Objection submission COM/2019/81 -

Council procedures, SARA re-referral and Public Notification requirements - continued.

Attachment B1 - Original DA - Stage 1 NE gradual merger from environmentally significant to extractive footprint

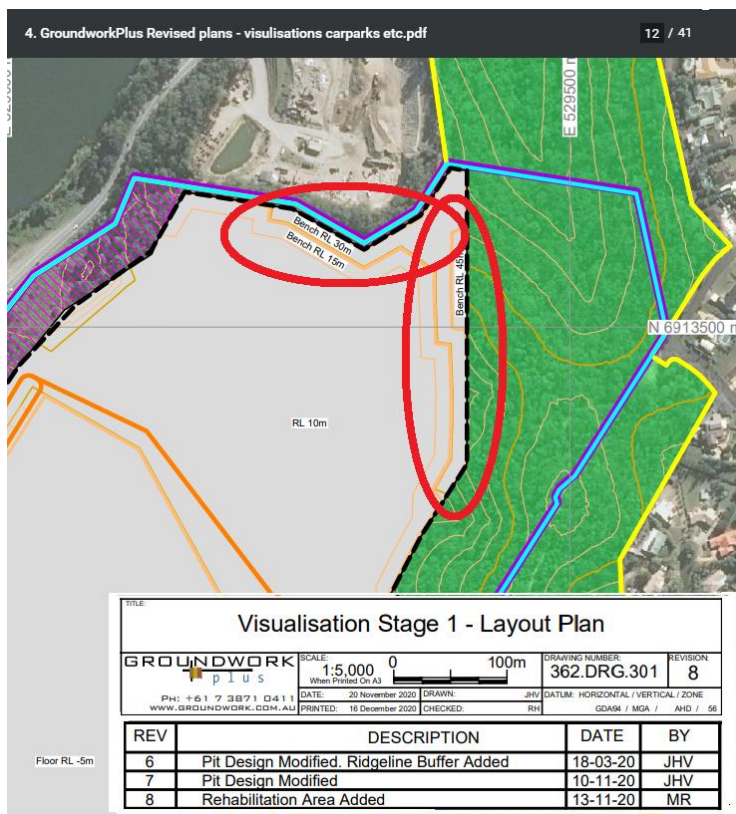
There has been a significant change in the northeast corner which will affect the residents in the northeast. Add the time of public notification it was shown that the merger from environmentally significant land (biodiversity and priority species) to extractive footprint would be a gradual process as shown in the ‘Visualisation Stage 1 - Layout Plan’, revision 3 (reproduced in attachment B1). However, the latest changes (now at revision 8) now reveal it will be (from the 50m peak) dangerous 15 m bench drops from 45m to 30m to 15m (reproduced in attachment B2).

I am sure residents, less than 200 metres of this location will be horrified of the safety implications if a child or the infirm or a pet were to fall foul of this dramatic drop at these locations. Especially as there would seem to be no safety fence (either now or planned as part of this DA) to stop the unwary entering the quarry at this location.

Attachment C1 - Original DA - Stage 1 - 'Proposed 40m Buffer' from Tamborine-Oxenford Road shown as NOT compromised

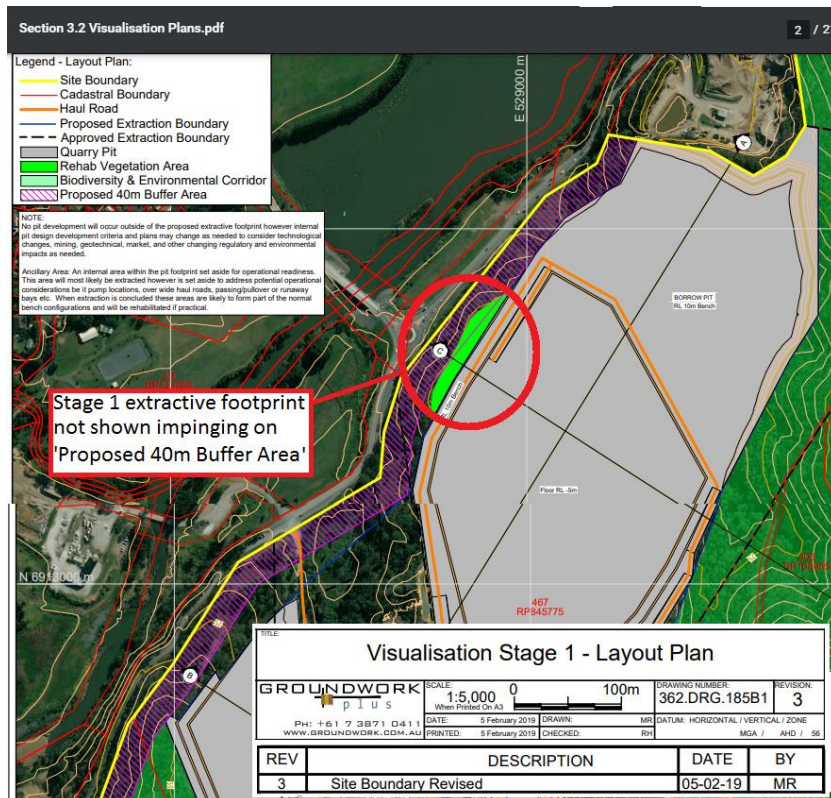
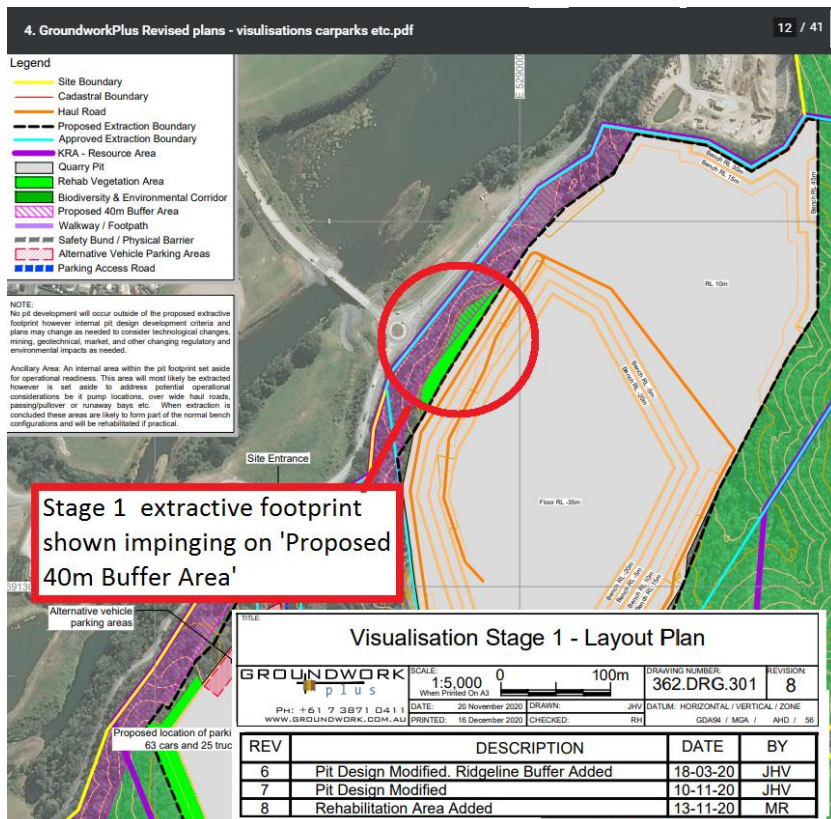
In the original development application it implies the 40m buffer area (as required by City Plan, Extractive Industry code, 9.3.8) is not impinged by the Stage 1 proposed extractive footprint along the Tamborine-Oxenford road (Attachment C1). However, in the February 2021 submitted drawing this required 40m buffer area is shown as clearly compromised (Attachment C2).

I find the original submission misleading as it clearly shows, at the time of public notification, the 'Proposed 40m buffer' is not compromised. However, this latest submission shows it is. I believe local residents should be entitled to their say on this new information that is not only clearly contra to the City Plan requirements but will also be highly viewable from the Tamborine-Oxenford Road, The John Muntz Bridge opposite and I would have thought from elevated views from the Tamborine Mountain road.

Attachment D1 - Original DA - Stage 8 - Rehabilitated around plant area and concrete production facility

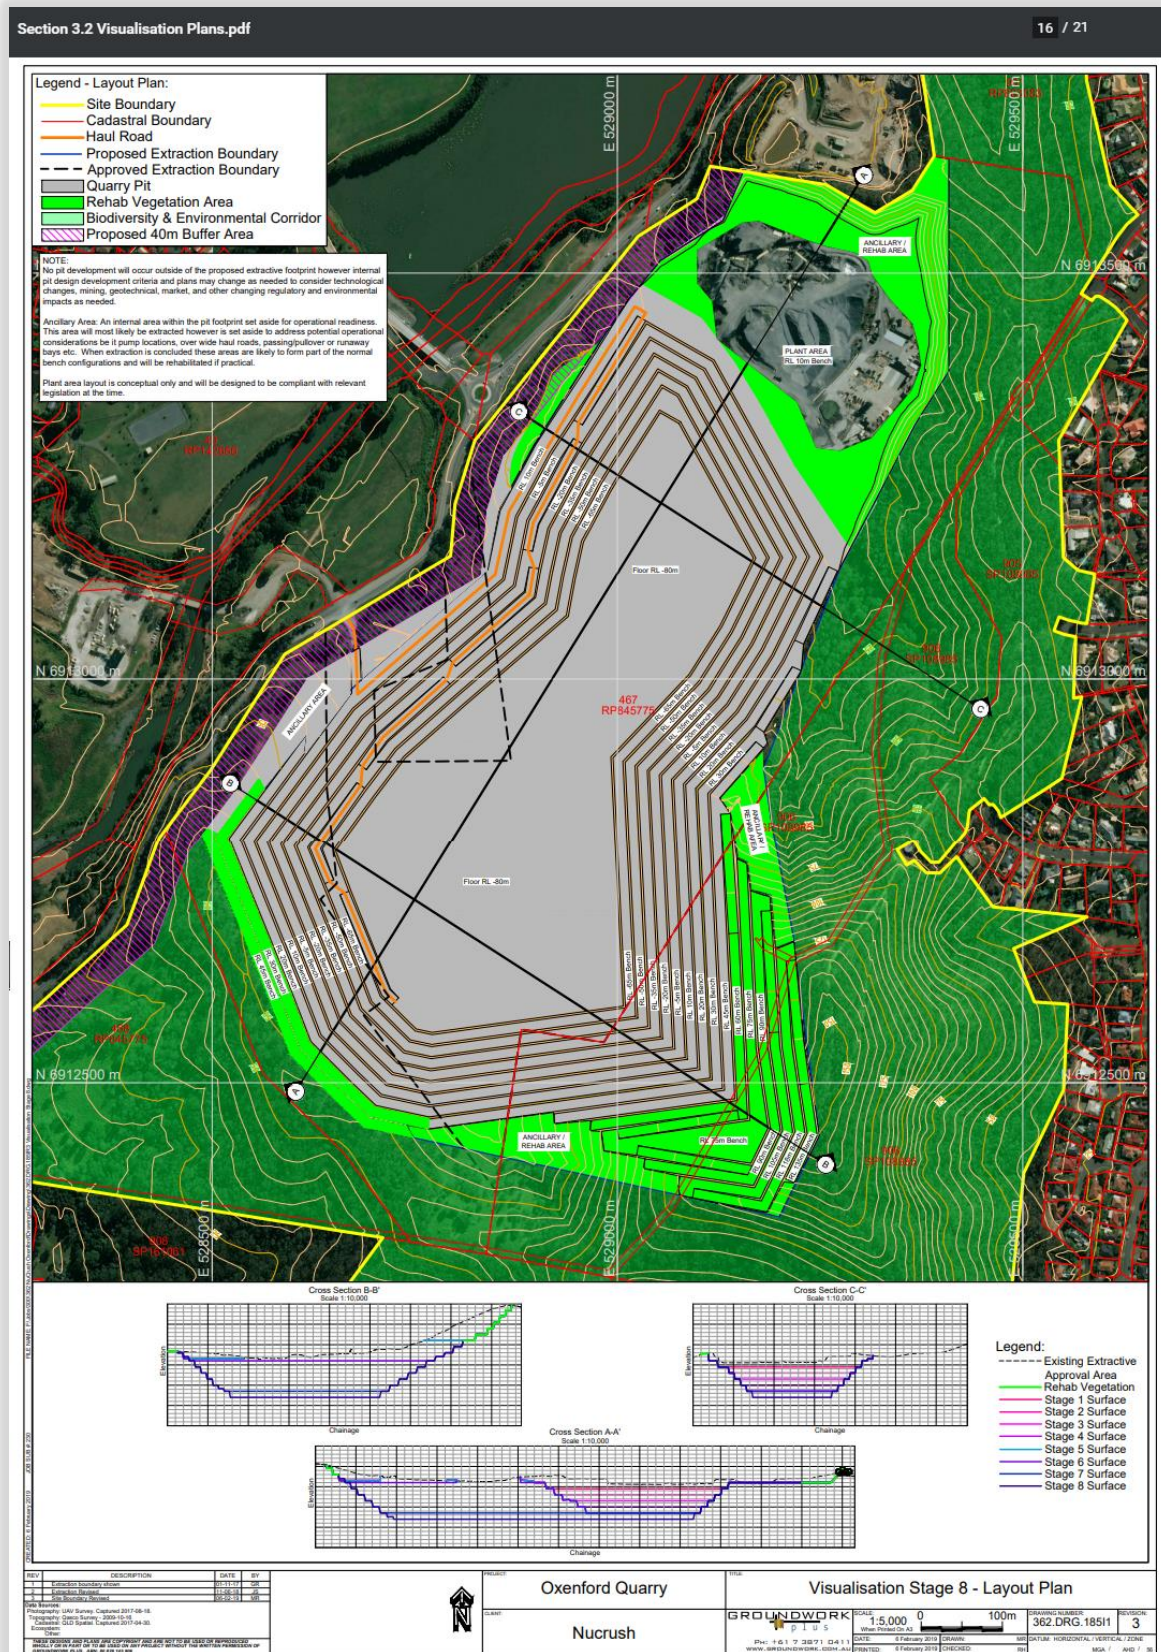
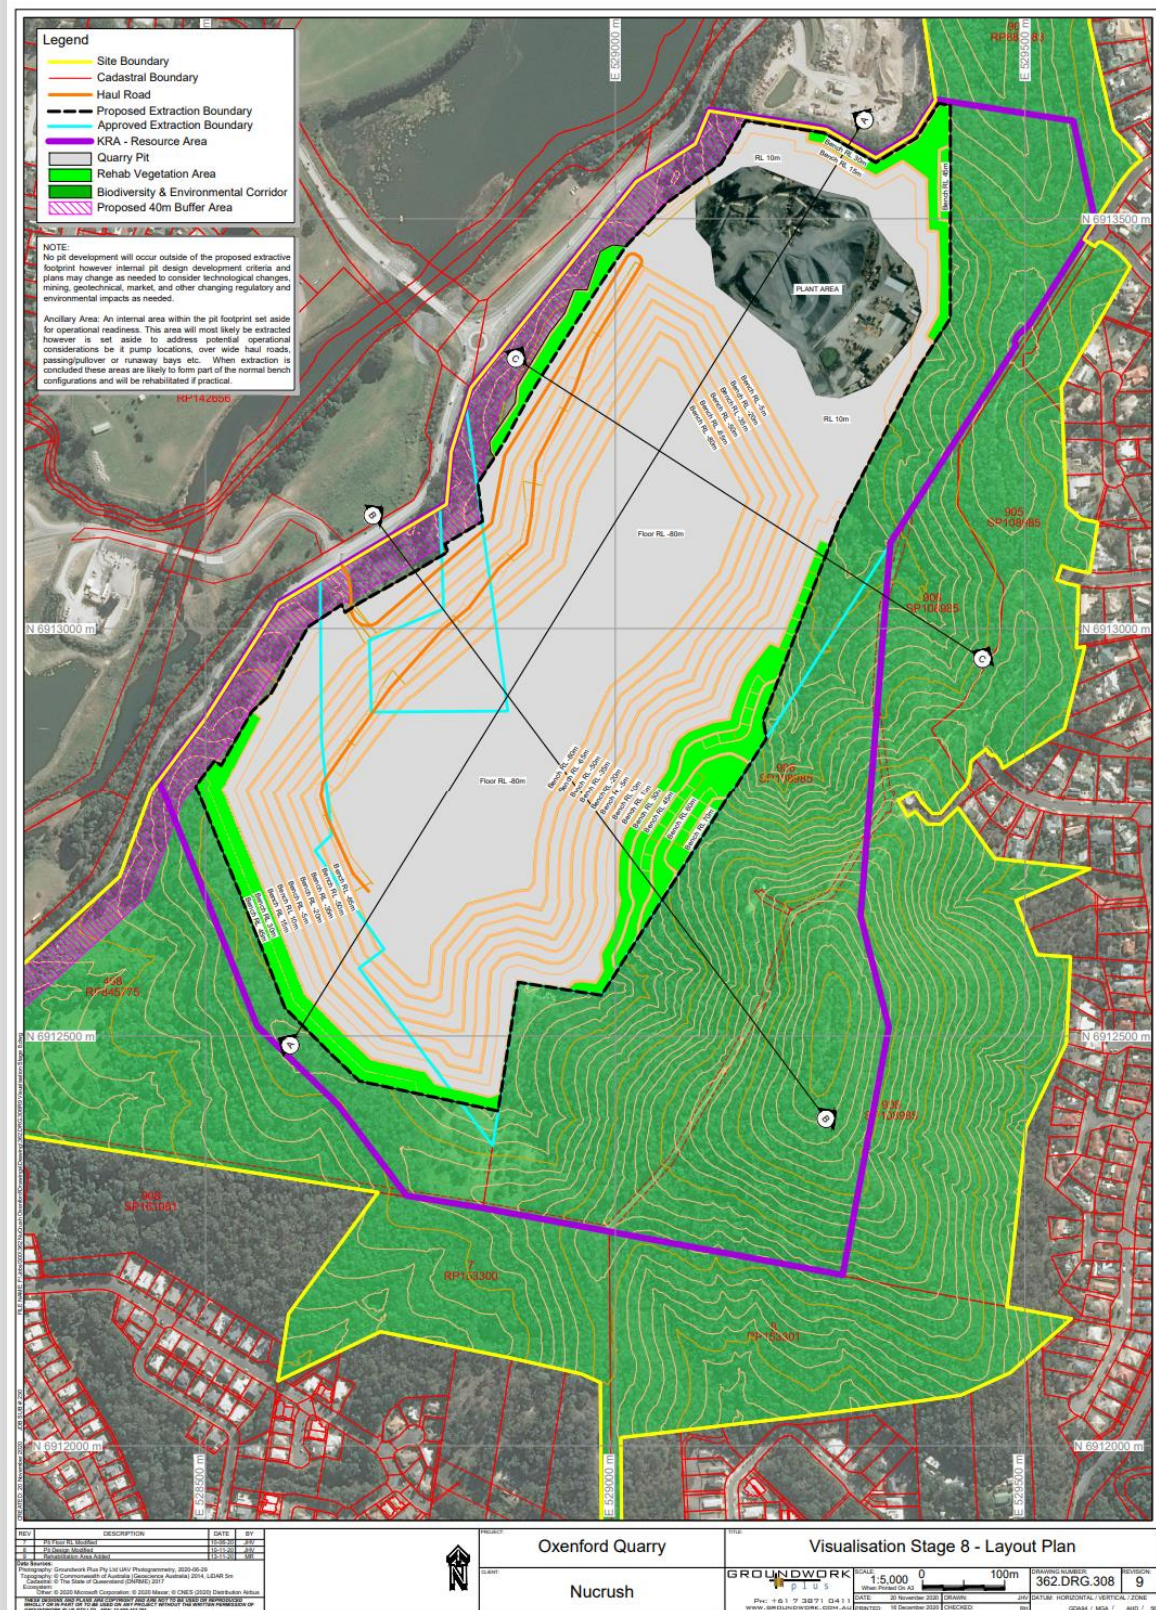
In the original development application submission the 'Visualisation Stage 8- Layout Plan' (Revision 3) shows the area to the north is rehabilitated seemingly to shroud views of the plant processing area and the Concrete Production / Batching facility (Attachment D1). Whereas in the latest submission the area is no longer rehabilitated at this stage (Attachment D2).
